City of Burlingame

Meeting Minutes Planning Commission

- c. 19 El Quanito Way, zoned R-1 - Application for Design Review and Hillside Area Construction Permit for a first and second floor addition to an existing single-unit dwelling. This project is Categorically Exempt from review pursuant to the California Environmental Quality Act (CEQA), per Section 15301 (e)(1) of the CEQA Guidelines. (Tim Raduenz, Form One Design, applicant and designer; Angelique and Chris Rypinski, property owners) (29 noticed) Staff Contact: 'Amelia Kolokihakaufisi

To: City of Burlingame	From: Tim Raduenz
Subject: 19 El Quanita Planning/Commission Responses	Date Sent: 10/30/24
	Number of Pages: 1

PROPOSED STORY POLE PLAN

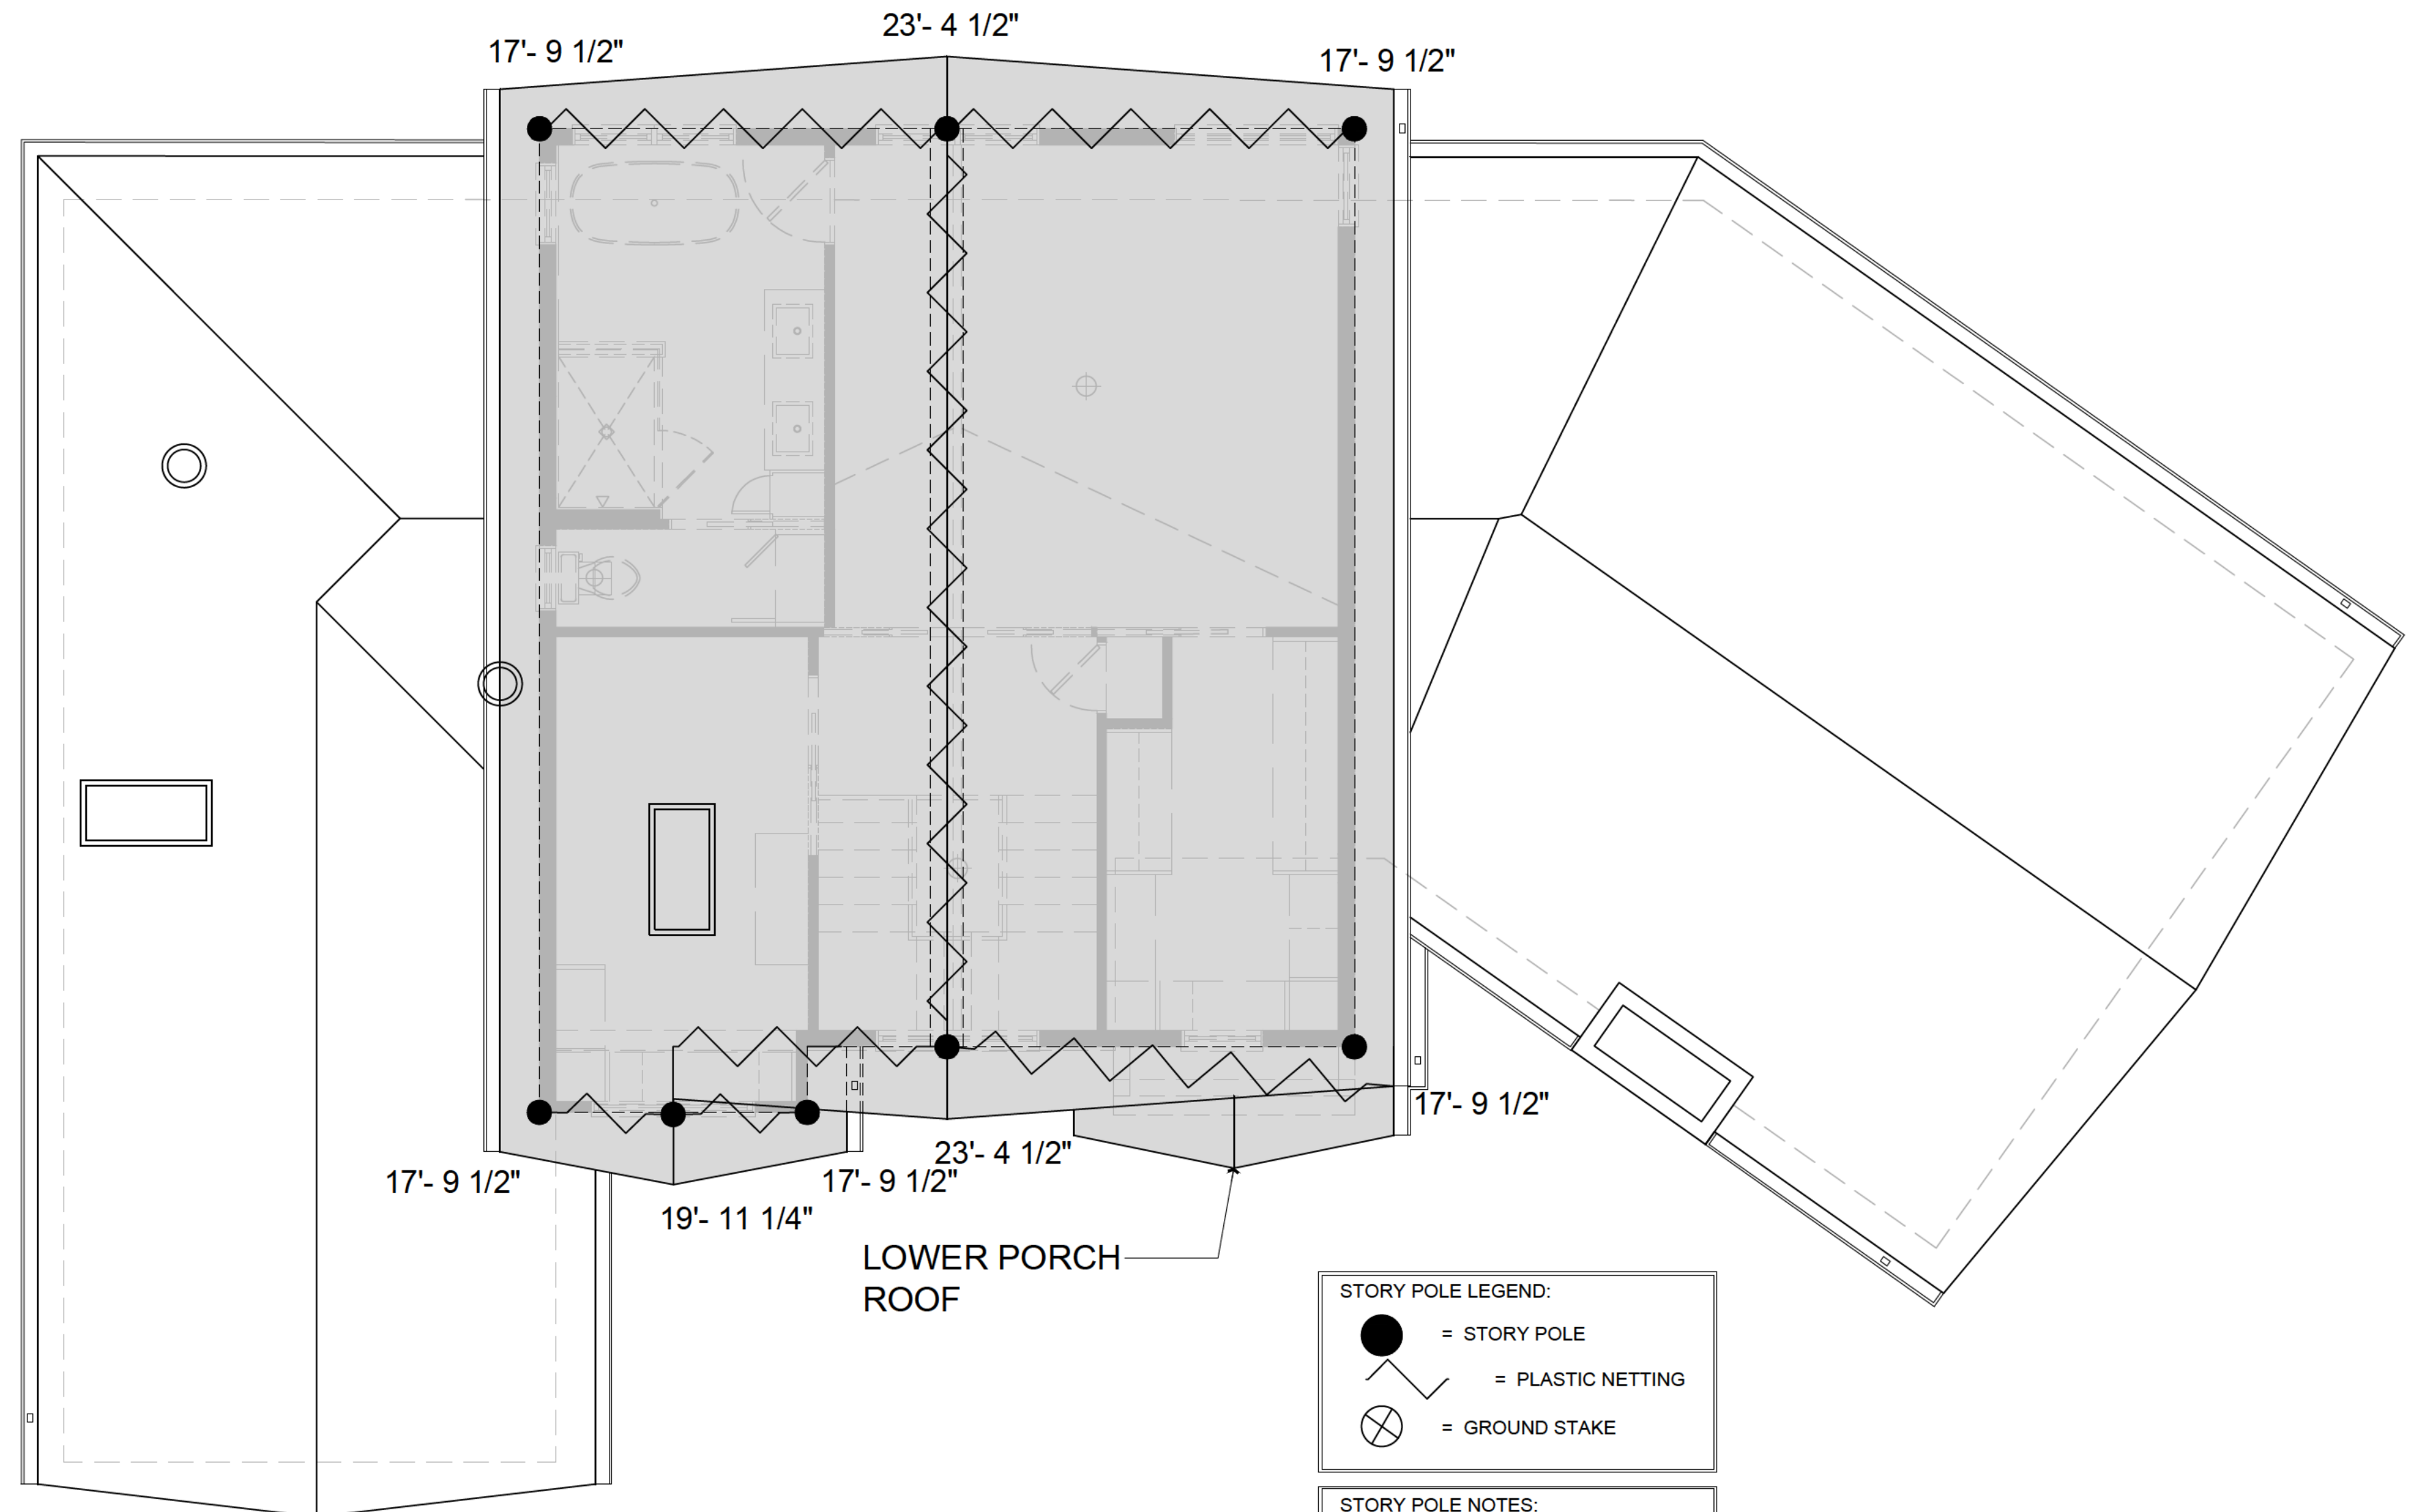
- > *Consider looking at other roof profiles and shapes.*
- > *Install story poles for the proposed addition.*
- > *I agree with my fellow commissioner. The story poles are needed. I want to note that I tried to reach out to the homeowner at 15 El Quanito Way but was unsuccessful. While I was there, I did walk to the side of the house towards the view. Though I was not at the level of the kitchen and the dining room, I can see that at least at street level or at grade, that there would be some view blockage with the second story addition over the house. I would like to see story poles installed by the time you get to the height of the dining room and kitchen area that clears that second story roof. But until the story poles are up, it's really hard to determine.*

- a. Install story poles: **Story Poles Installed**
- b. Inconsistency of window casings being shown on drawings and differs from renderings: **renderings was updated to match**
- c. Look at different roof shapes that may be flatter: **we can reduce wall height 12” to go with 7’ wall heights if that helps with view.**
- d. Make first floor stucco to be consistent with rest of house and increase horizontal element of addition: **We have taken your recommendation on this and hope this helps with the overall style.**
- e. Consider windows on right side elevation: **We can add these windows back in, hopefully we can get an approval so we can move forward with design process!**
